Massachusetts Military Reservation

Final Explanation of Significant Differences for Chemical Spill-4, Chemical Spill-20, Chemical Spill-21, Fuel Spill-13, Fuel Spill-28, and Fuel Spill-29 Groundwater Plumes

September 2008

Prepared by:
Jacobs Engineering Group Inc.

Figure 2-3

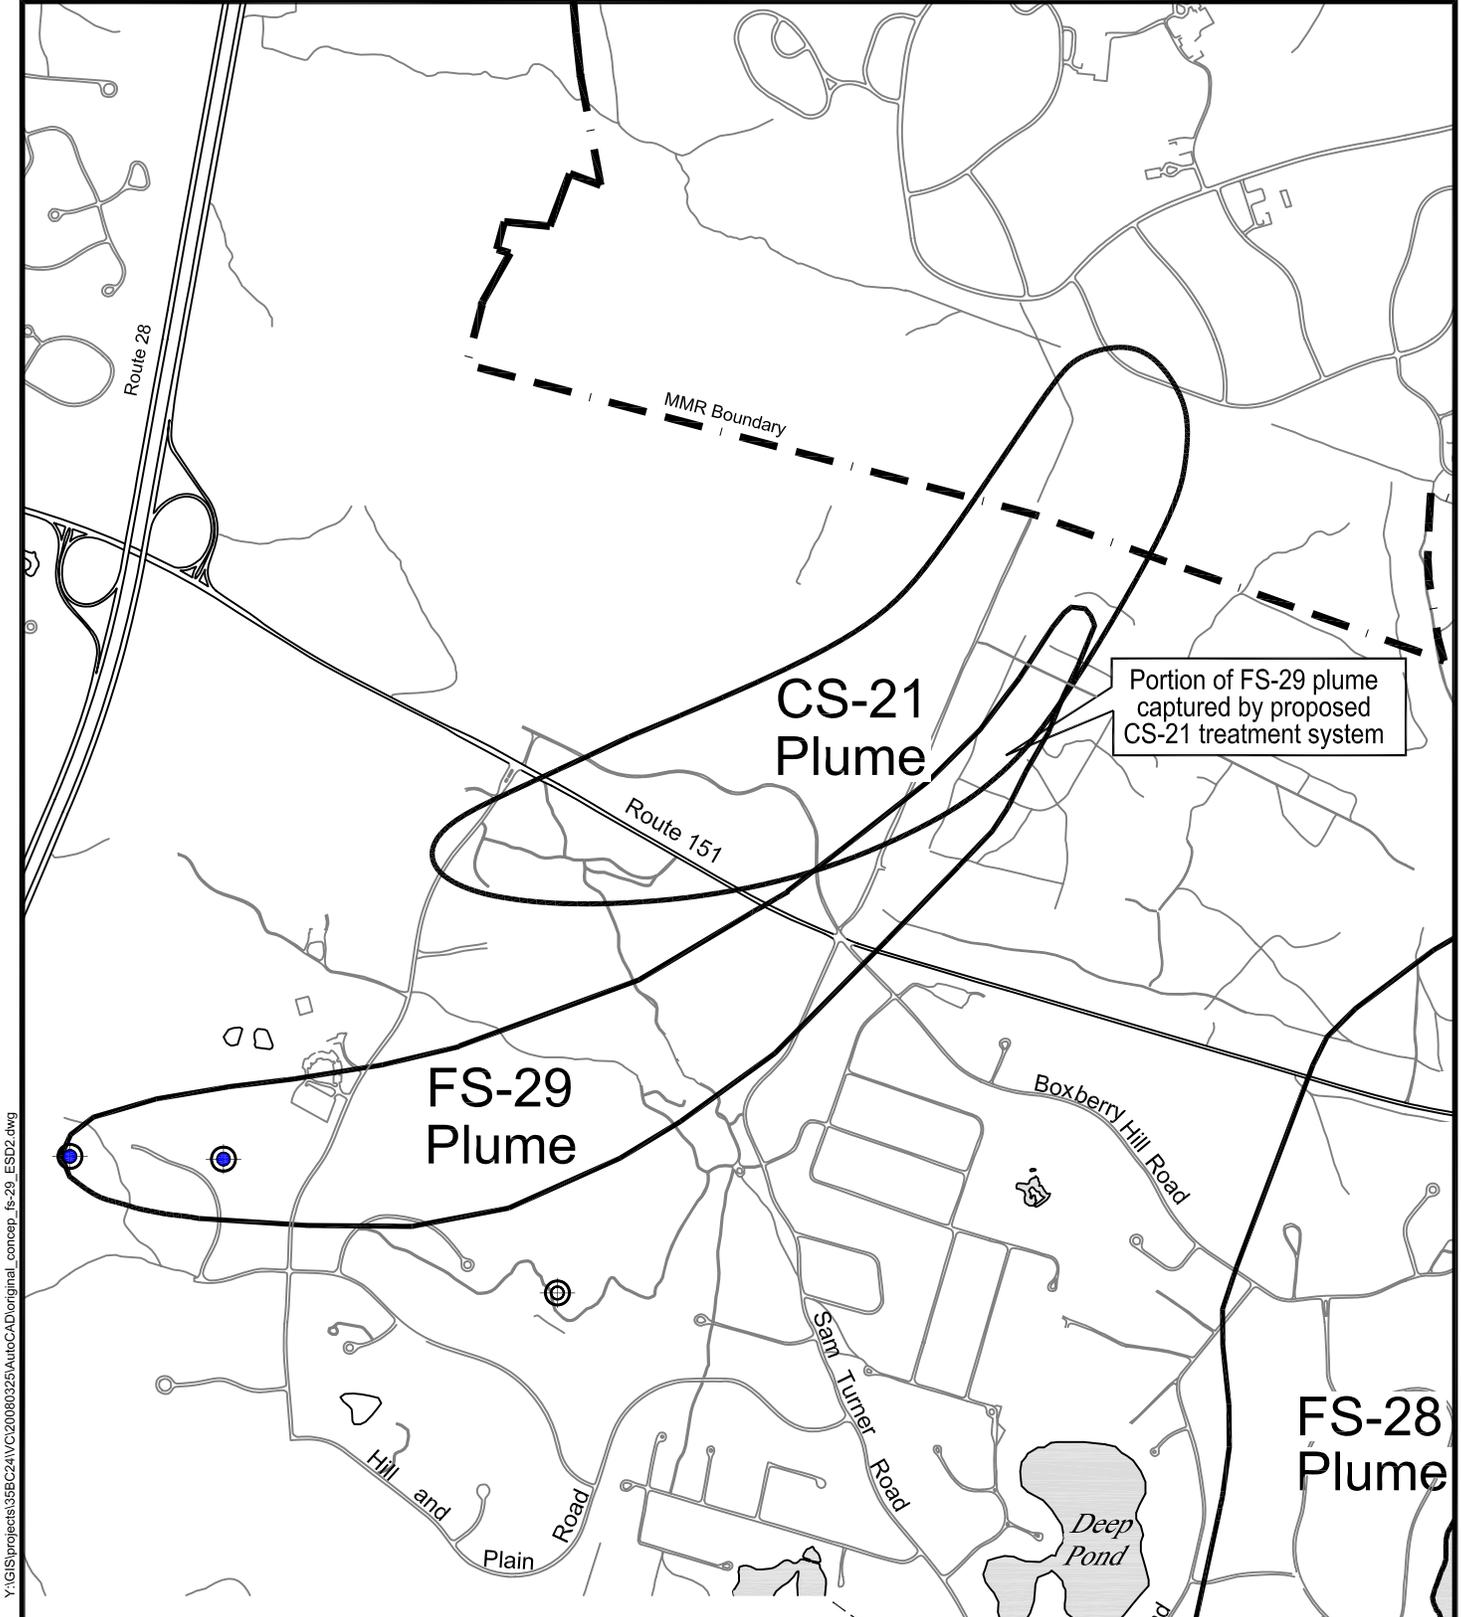
For the CS-4 plume, the conceptual design called for replacing the existing extraction well fence with a new extraction system that used approximately three extraction wells located along the longitudinal axis of the plume (Figure 2-3). Groundwater modeling conducted during the feasibility study indicated that approximately 300 gpm would be needed to capture the plume. It was envisioned that 200 gpm would be processed at the existing treatment facility and that the balance (approximately 100 gpm) would be processed at a new treatment facility to be built for the adjacent CS-20 plume.

The conceptual design for the CS-20 plume included the construction of an ETR system capable of treating 500 gpm for hydraulic capture and treatment of plume contaminants. The water would be treated at a new treatment facility to be built for the CS-20 plume. Because the goal of the ETR system was plume capture, the extraction system conceptual design consisted of an extraction well located at the most downgradient (southern) extent of the plume (Figure 2-3).

The conceptual design for the CS-21 plume included the construction of an ETR system capable of treating 1,200 gpm in the upgradient portion of the plume and a separate leading edge extraction and reinjection well pair and treatment system processing 200 gpm. The system would be designed for hydraulic capture and treatment of plume

contaminants. Because the goal of the ETR system was plume capture, the extraction system conceptual design included an extraction well located at the most downgradient (southern) extent of the plume (Figure 2-3).

Figure 2-4

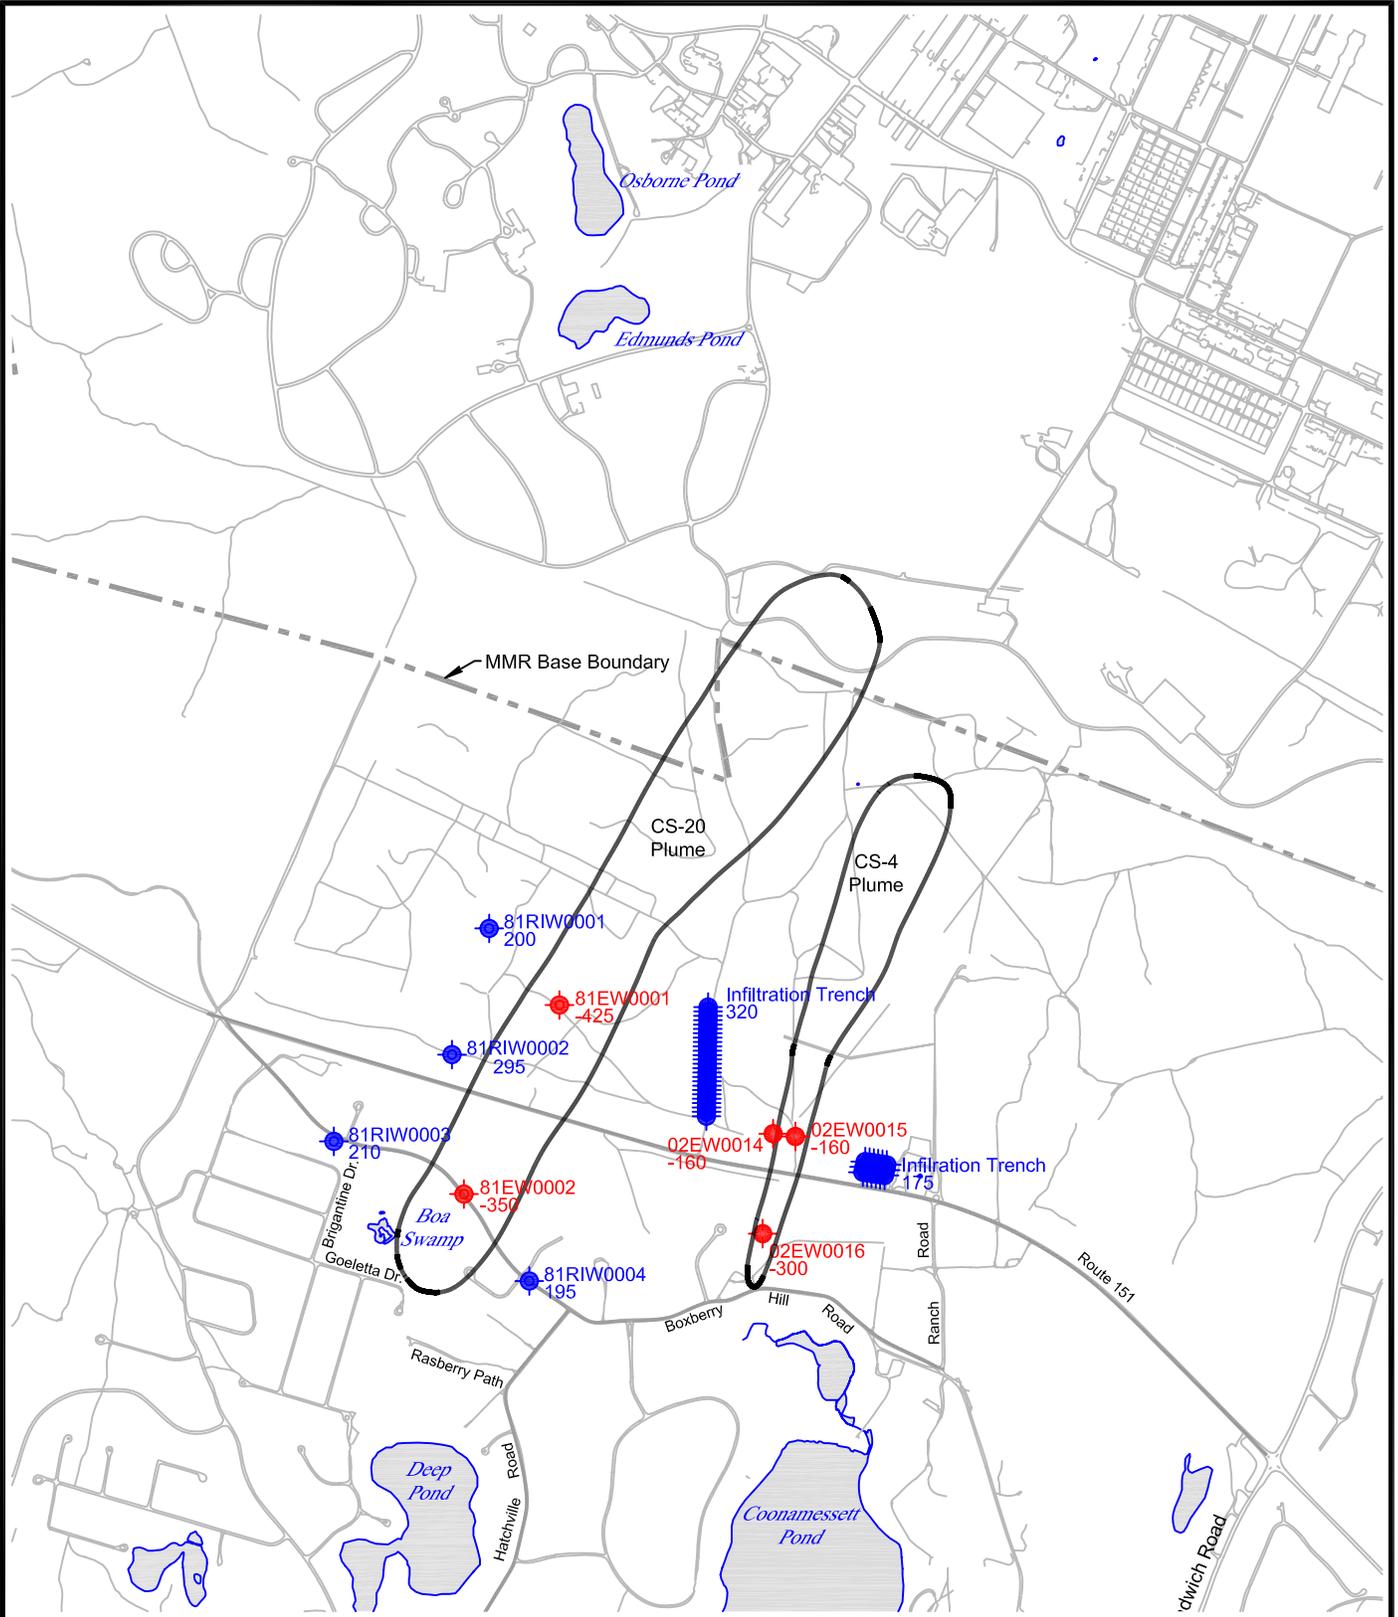
The conceptual design for the FS-29 plume included the construction of an ETR system capable of treating 600 gpm for hydraulic capture and treatment of plume contaminants. Modeling indicated that a small portion of the upgradient (northeastern) part of the FS-29 plume would be captured by the ETR system that was planned for the adjacent CS-21 plume. Because the goal of the ETR system was plume capture, the extraction system conceptual design consisted of two extraction wells located in the downgradient (western) portion of the plume (Figure 2-4).

Figure 3-1

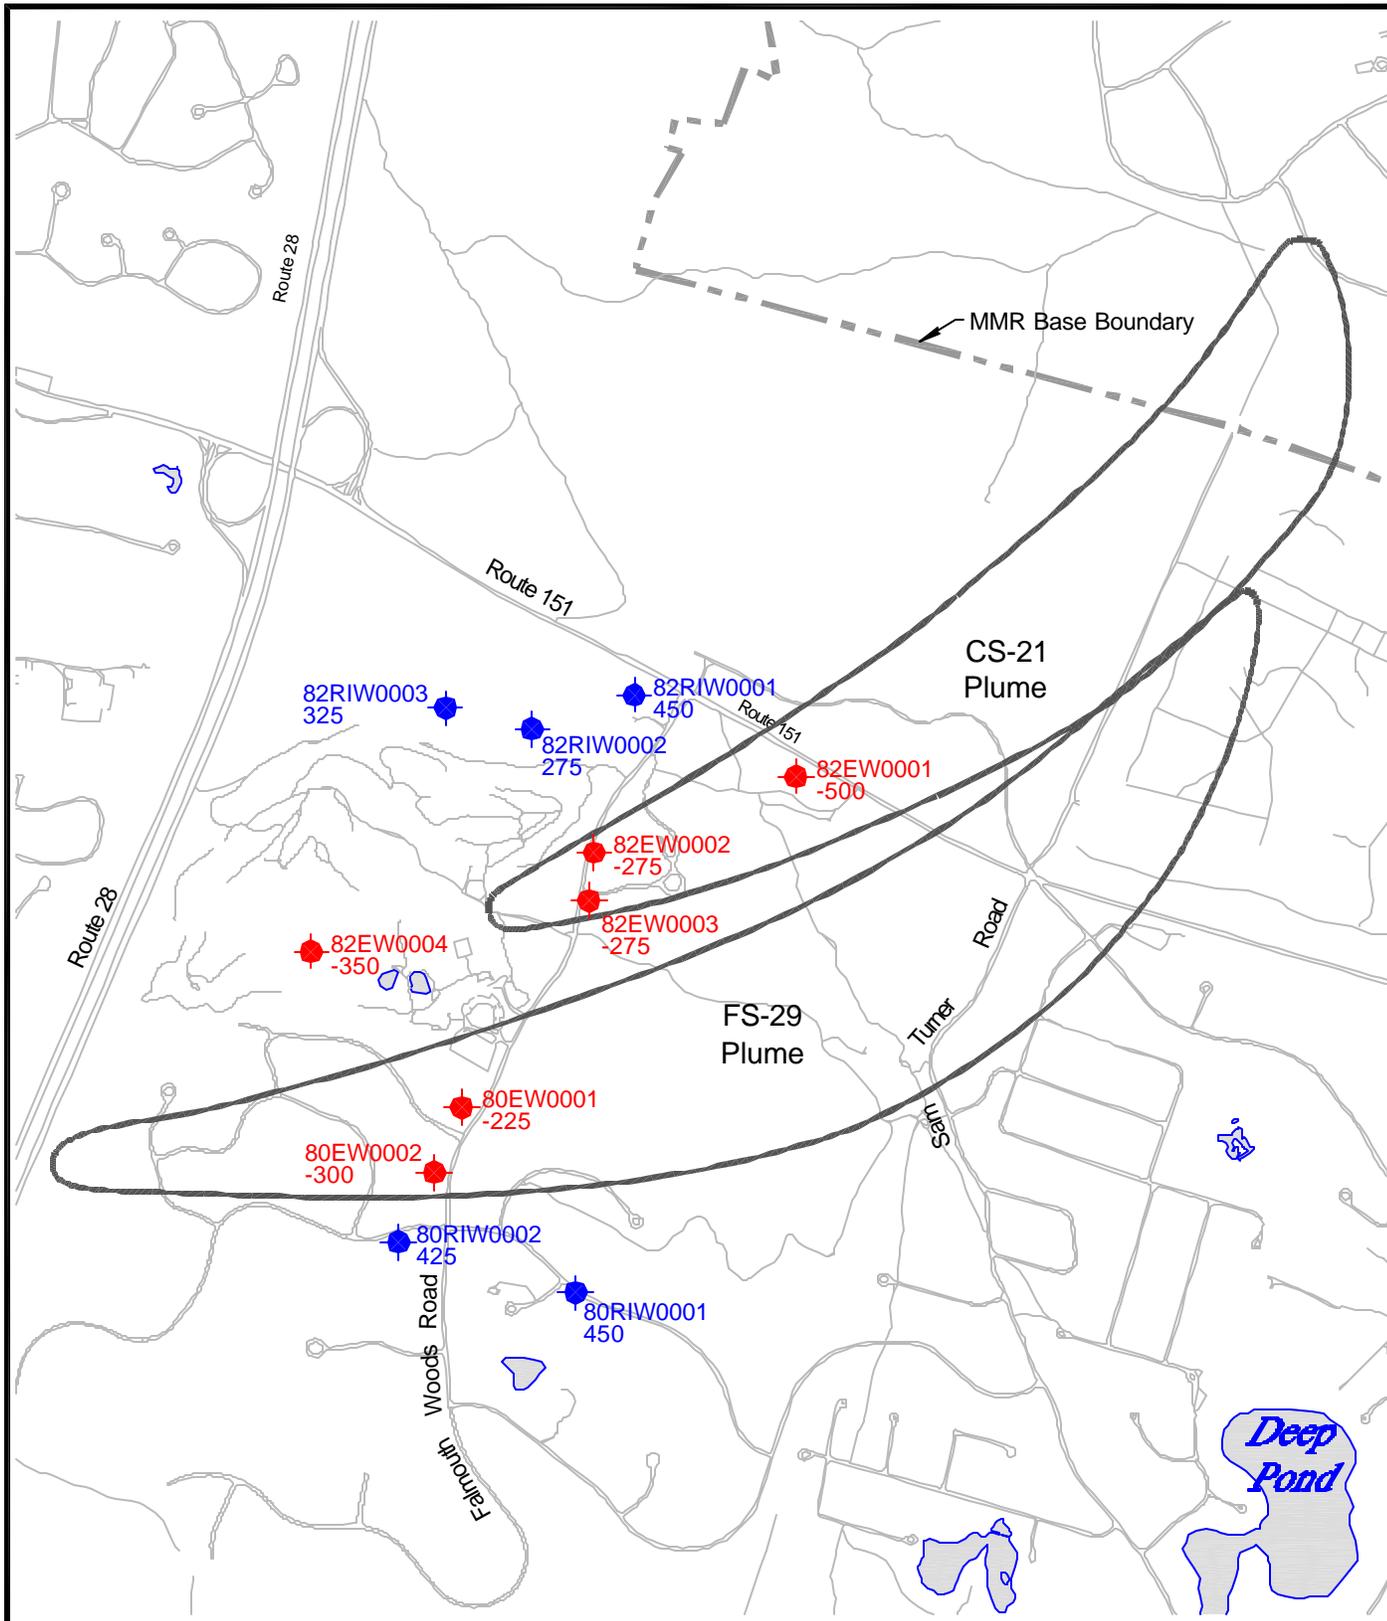
The ETR system that was built treats and discharges water extracted from the CS-4, CS-20, and FS-29 plumes¹. The final wellfield design for the plumes is presented on Figure 3-1 and Figure 3-2. As illustrated in Figure 3-1 and Figure 3-2, contaminated groundwater from within the CS-4, CS-20, and FS-29 plumes is extracted as follows:

- CS-4 plume: Three extraction wells are used to remove groundwater from the CS-4 plume. A pair of wells oriented cross gradient from each other are located between the former 13-well extraction fence (now abandoned) and Route 151. A third well is located closer to (yet upgradient of) the leading edge of the plume between Route 151 and Boxberry Hill Road. The total flow rate from the three CS-4 extraction wells is 620 gpm.

- CS-20 plume: Two extraction wells will be used to remove groundwater from the CS-20 plume. The pair of wells is axially oriented; one north of Route 151 and one located on Boxberry Hill Road. The total flow rate from the two CS-20 extraction wells is 775 gpm.

Figure 3-2

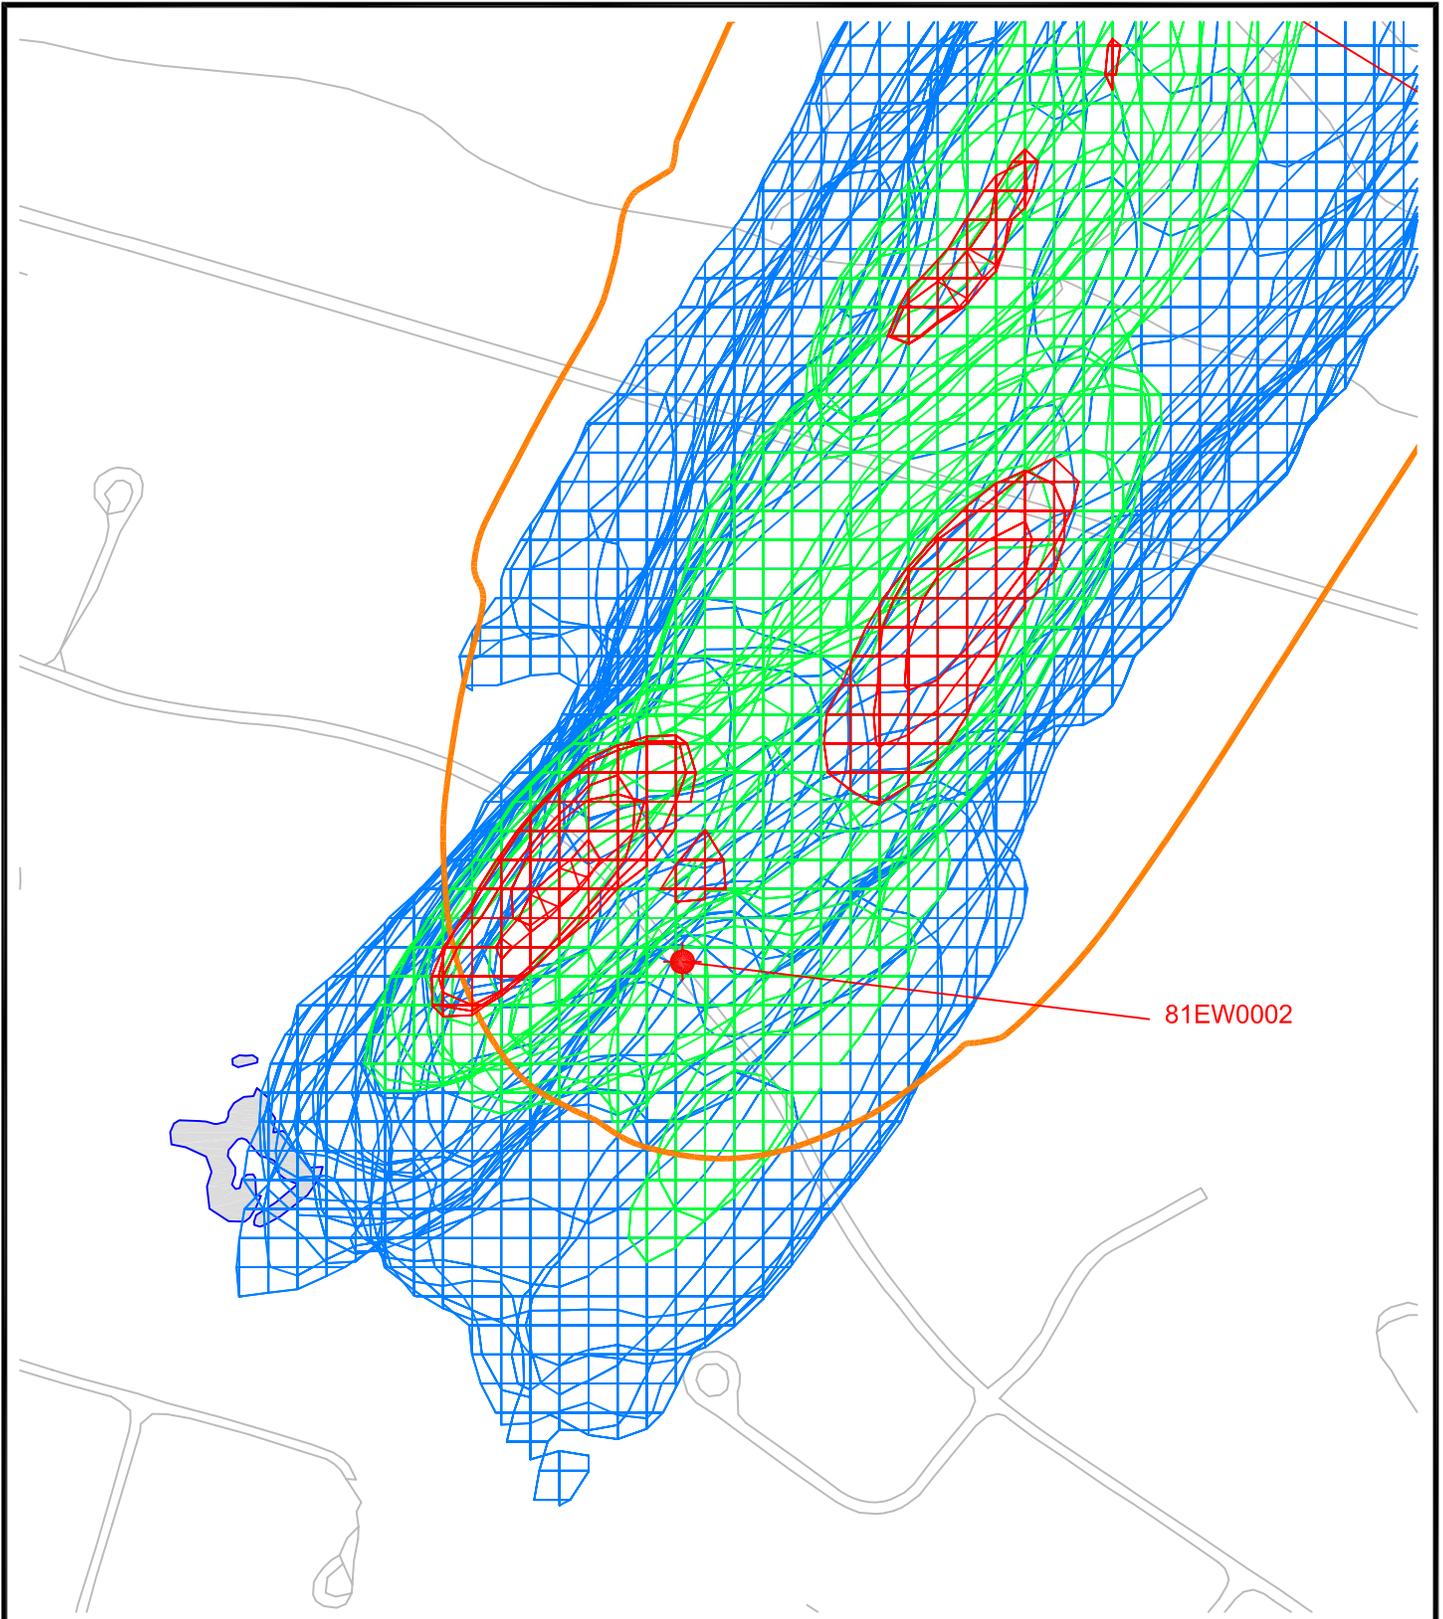
- FS-29 plume: Two extraction wells will be used to remove groundwater from the FS-29 plume. The pair of wells will be oriented crossgradient from each other and located slightly west of Falmouth Woods Road, about 2,000 feet upgradient of the leading edge of the plume. The total flow rate from the two FS-29 extraction wells is 525 gpm.
